FLUID LEAKAGE FROM BRAKE RESERVOIR CAP

Last Issued: 11/15/2002

2001-2002 Tributes

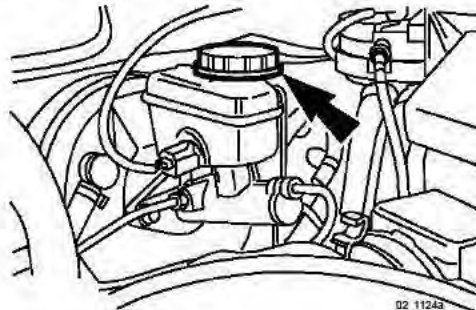
Some vehicles may exhibit fluid leakage from the brake reservoir cap. This may be caused by the insufficient sealing of the cap.

To improve the sealing, a new brake reservoir cap is available to prevent this condition.

1. Verify concern.
2. Remove the brake reservoir cap by turning counterclockwise.
3. Install a new cap and turn it clockwise to secure.

NOTE: Turn the cap until it completely stops.

4. Replace Caution Label with a new one. (You can attach the new label over the old one.)

- Be aware of the direction of the label: the text part faces toward the front of the vehicle.
- To prevent the label from peeling off, wipe the leaked fluid or dust completely off the tank.
- You can use brake cleaner to degrease if necessary.
